DRAFT EAST OF ABERLINE PRECINCT STRUCTURE PLAN (AMENDMENT C217warr)

Thank you for the opportunity to make a submission in relation to Amendment C217warr to the Warrnambool Planning Scheme and specifically the draft *East of Aberline Precinct Structure Plan (PSP)*, *Development Contributions Plan (DCP)* and accompanying planning scheme provisions.

Warrnambool City Council (**Council**) are pleased to provide the following submission in response to Amendment C217warr (**the Amendment**).

FIGURE 2: PROPOSED INTERSECTION LOCATIONS

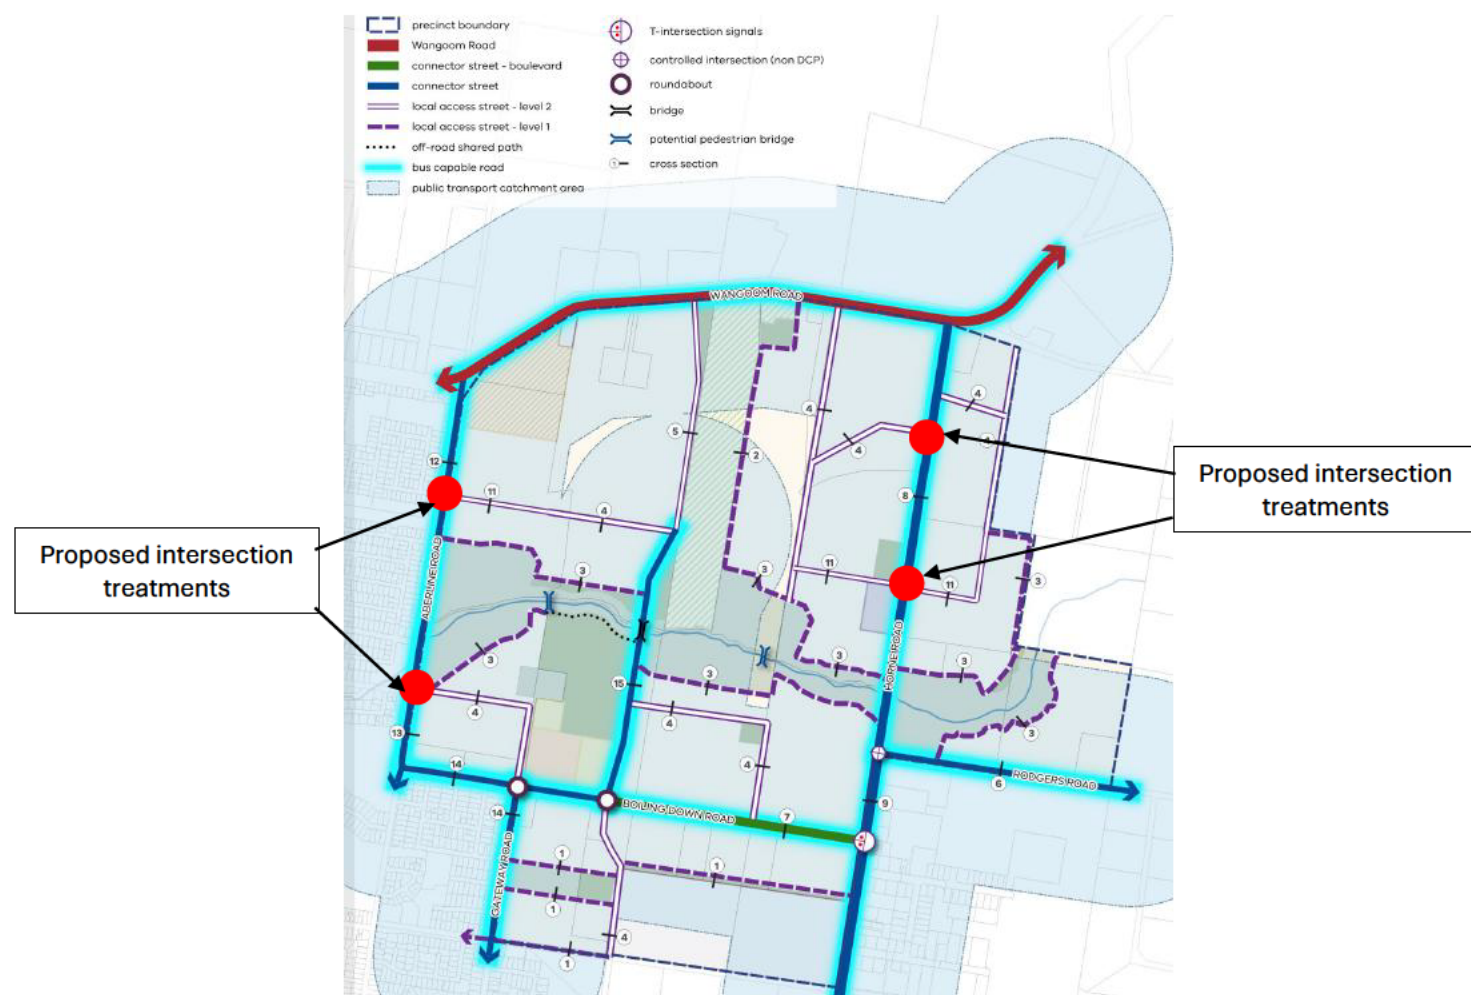
The intersection at Horne Road and the Neighbourhood Activity Centre (NAC) is currently shown on Plan 4 *Movement Network* of the PSP (**Figure 2** below) as a 'controlled intersection (non DCP)'. An earlier version of the O'Brien report recommended traffic signals at this intersection. At a minimum, at least a roundabout should be provided for in this location, as well as potentially another roundabout between the NAC and Wangoom Road, at the local access street. We also suggest that additional intersection treatments (roundabouts) could be provided at Horne Road-Rodger Road, Aberline Road - Whites Road and between Russell's Creek and Wangoom Rd, as shown in the Figure below. Where these intersection treatments are non-DCP items, it should be clear what the delivery expectation is or what the trigger for these works is (which developer/s are expected to deliver the works).

Treatments at these intersections would assist safety in Horne Road by managing traffic conflicts at the intersections and by providing a lower speed environment along Horne Road, supporting the proposed speed limit of 60km/hr. If these intersections are not included in the DCP, Council is concerned that there will be conflict between developers over who must deliver each roundabout. In particular, the intersection at Horne Road-NAC is located between properties in different ownership, which may cause delivery issues.

Based on the redistribution of traffic generation, the traffic volumes on Horne Road are anticipated to reduce significantly. As such, the proposed signalised intersection at Horne Road-Boiling Down Road could be revised to a roundabout. This would result in a significantly lower project cost. If necessary, the roundabout could have a 2-lane entry and exit along Horne Road. Further, Council highlights that the geometry required for a roundabout allows for upgrading to a signalised intersection if required in the future, however the geometry for a signalised intersection (or a formalised cross intersection) does not allow for a roundabout to be delivered instead (insufficient splays).

- O'Brien Traffic to consider inclusion of additional roundabouts at Horne Road and Aberline Rd, as identified in **Figure 2** above.
- Amend Plan 4 *Movement Network* to complete the 'bus capable' route along the north-south connector street.
- Consider changing IN-01 to a roundabout.

FIGURE 4: CIVIC PRECINCT CONCEPT PLAN (EAST OF ABERLINE DCP)

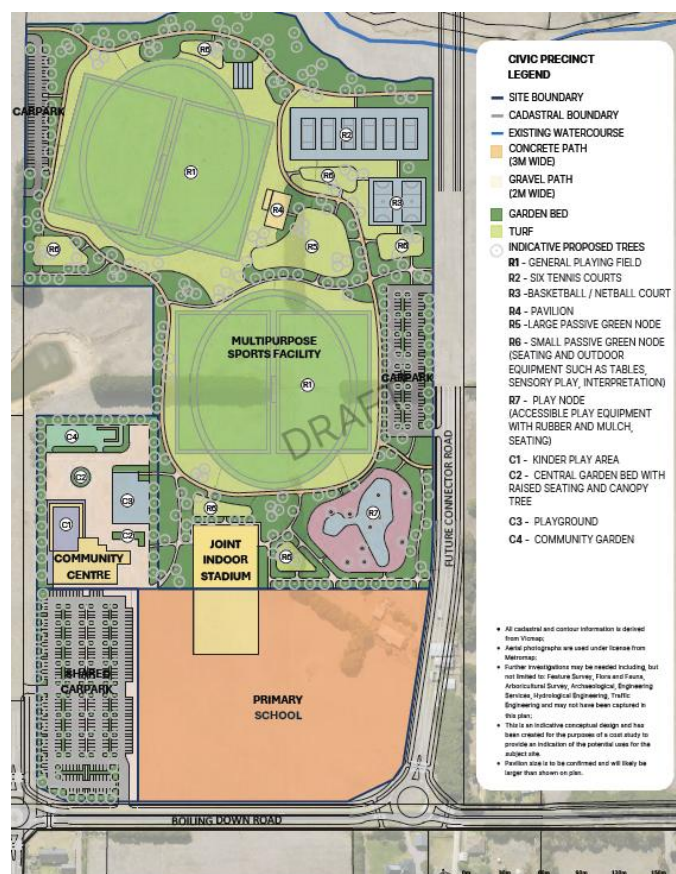
The PSP currently proposes one area of active open space SR-01, located centrally adjacent to the proposed community hub. This sports reserve is a non-standard size (10.65ha) and shape. In order to reduce surplus land associated with this reserve, a more standard size (8-10ha, as per the VPA benchmarks) and shape is recommended. Further, the concept plan for this reserve included in the DCP, as shown below, does not match the facilities proposed to be delivered in this reserve. Any reference to sports facilities not funded by the DCP should be deleted.

Council is not certain what form the playing fields and hard-court areas should take. Both the fields and courts should be identified in a more general way to enable flexibility in the sports which will be accommodated closer to the time of delivery based on need at that time.

FIGURE 5: PROPOSED PAO MAP

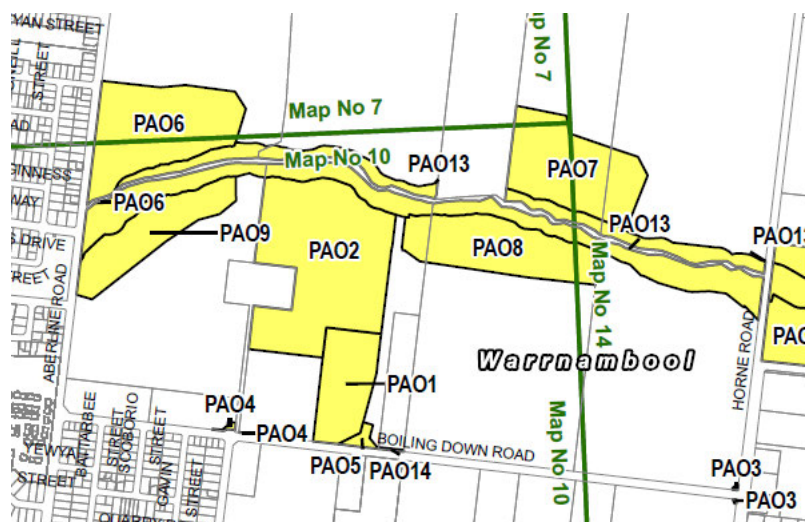
Clarification is also required to confirm the approach to the two CI-01 projects, noting that they are proposed to be acquired under two separate PAOs, as shown in **Figure 5** below. Council is also concerned that applying the PAO to the community and sports facilities (POA1 & PAO2) may not align with the purpose of a PAO.

Depending upon the agreed configuration of Boiling Down Road, there is a possibility that some PAO may also be required to ensure that configuration can be delivered.
